ECE/TRANS/WP.29/2008/96
24 July 2008

Proposal for Supplement 4 to the 02 series of amendments to Regulation No. 46
(Devices for indirect vision)

Submitted by the Working Party on General Safety Provisions */

Figure 2: Example of rear view mirror bending-test rig

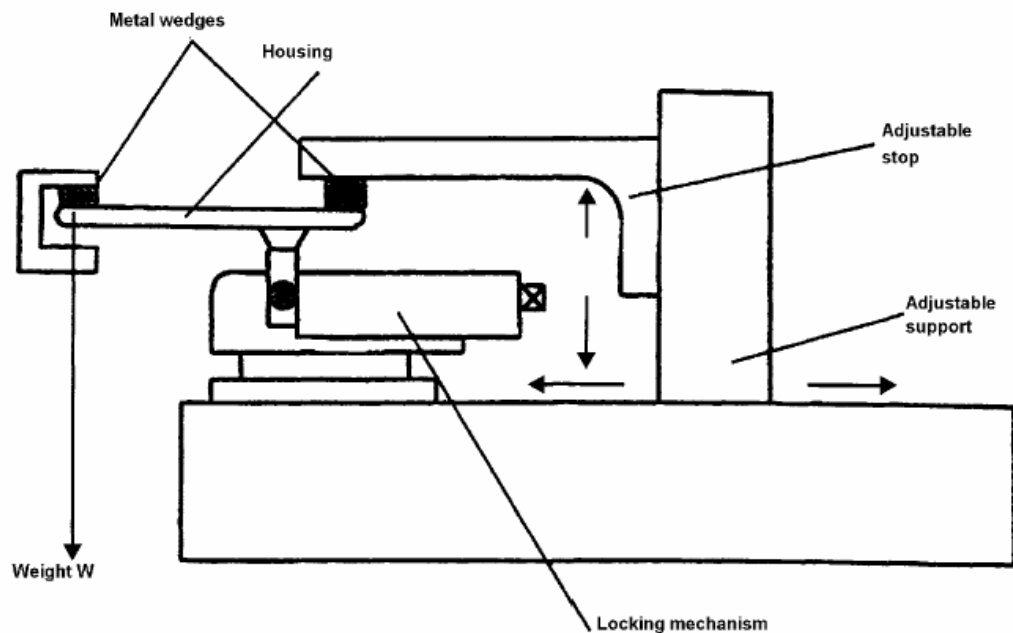
Insert the following new paragraph 6.1.3.2.3.:

"6.1.3.2.3. Bending test on the protective housing attached to the stem (Class VII)

6.1.3.2.3.1. Description of test

The protective housing is placed horizontally in a device in such a way that it is possible to lock the attachment support adjusters firmly. In the direction of the largest dimension of the housing, the end closest to the point of attachment on the adjuster for the support shall be immobilized by a 15 mm-wide rigid stop covering the entire width of the housing.

At the other end, a stop identical to the one described above is placed on the housing so that the specified test load can be applied to it (Figure 2).

The end of the housing opposite to that where the force is exerted may be locked rather than held in position as shown in Figure 2.

6.1.3.2.3.2. The test loading shall be 25 kilograms and shall be maintained for one minute."

Figure 10: Field of vision of Class VII mirrors"

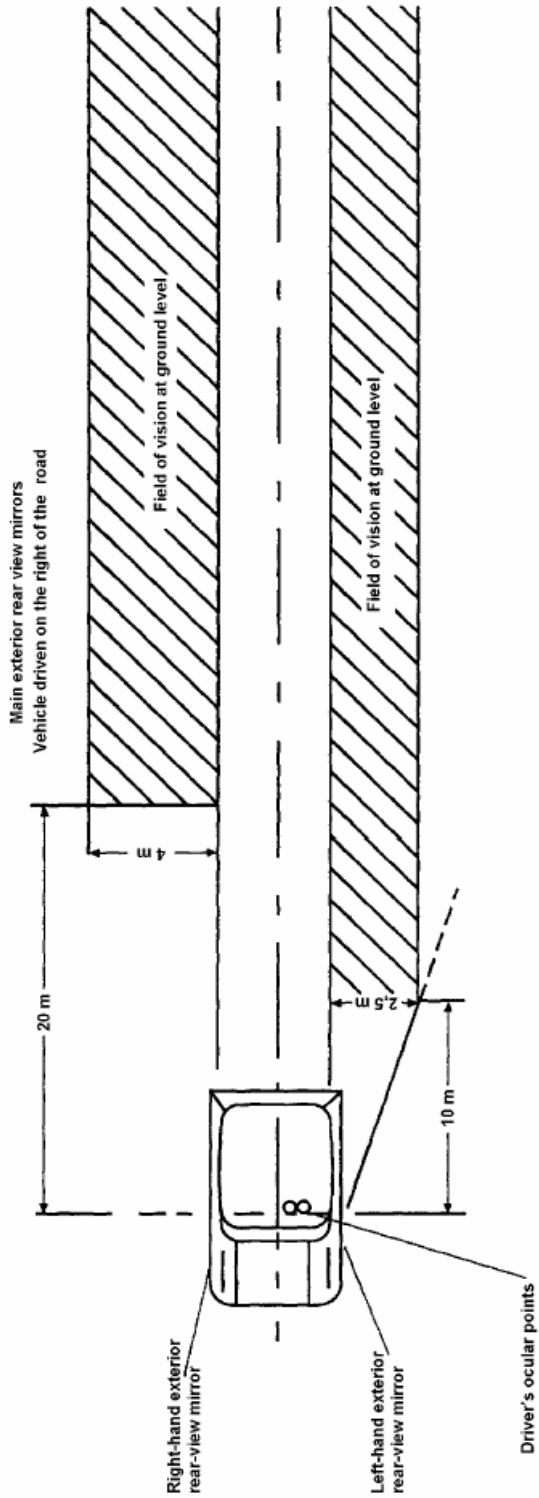
Insert new paragraphs 15.2.4.7. to 15.2.4.7.2, to read:

"15.2.4.7. L-category mirror (Class VII).

15.2.4.7.1. Exterior rear-view mirror on the driver's side

The field of vision must be such that the driver can see at least a 2.50 m wide, flat, horizontal portion of the road, which is bounded by a plane parallel to the median longitudinal vertical plane and passing through the outermost point of the vehicle on the driver's side of the vehicle and extends from 10 m behind the driver's ocular points to the horizon (see Figure 10).

15.2.4.7.2. Exterior rear-view mirror on the passenger's side

The field of vision must be such that the driver can see at least a 4 m wide flat, horizontal portion of the road which is bounded by a plane parallel to the median longitudinal vertical plane passing through the outermost point of the vehicle on the passenger's side and which extends from 20 m behind the driver's ocular points to the horizon (see Figure 10).
